# RS code scheme to protect “un-coded” bits at 40GBASE-T

Phil Sun, Peter Wu, Zhenyu Liu and William Lo  
Marvell Semiconductor

# Comments to D1.0

# The Bit mapping:

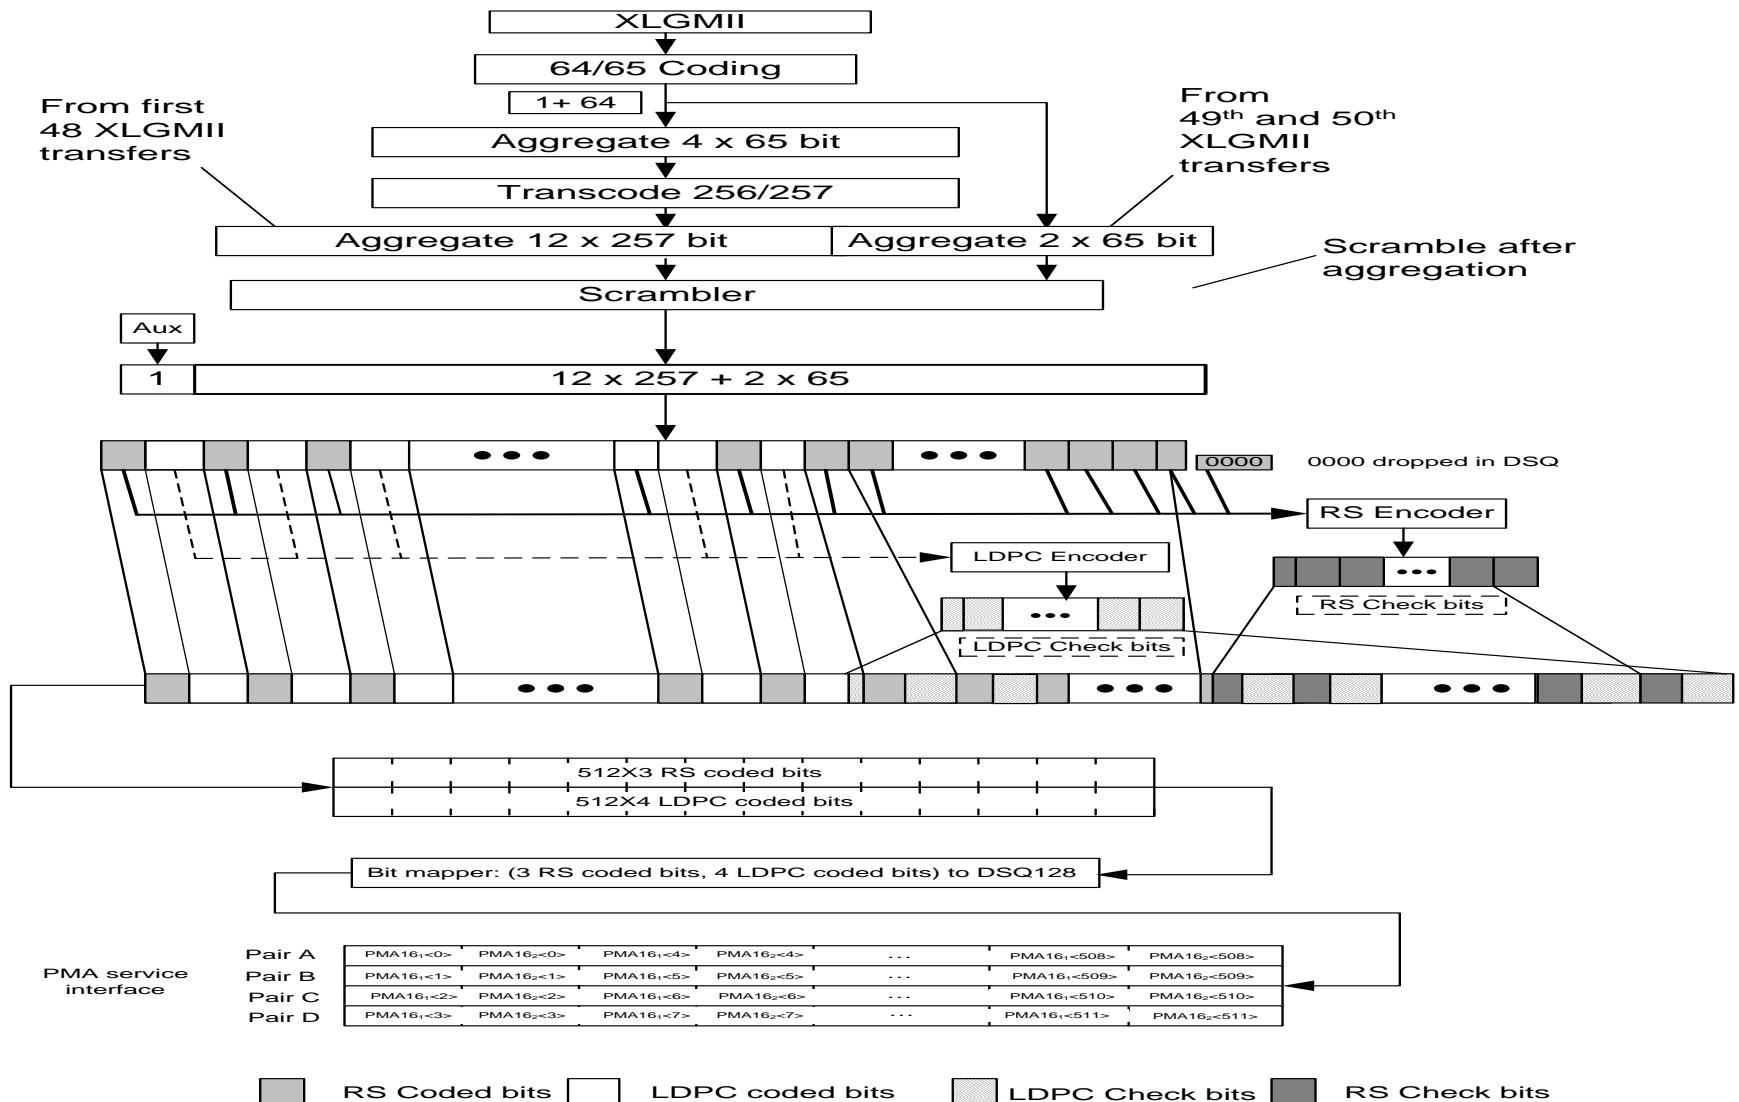
- ❑ Some issues with the figures:
  - Figure 98-13
    - It is copied at here “ as is”
    - The issues have been resolved in other comments
  - Figure 98-9
    - Some comments regarding the labels
    - Suggest to be replaced with Figure in Page 6.
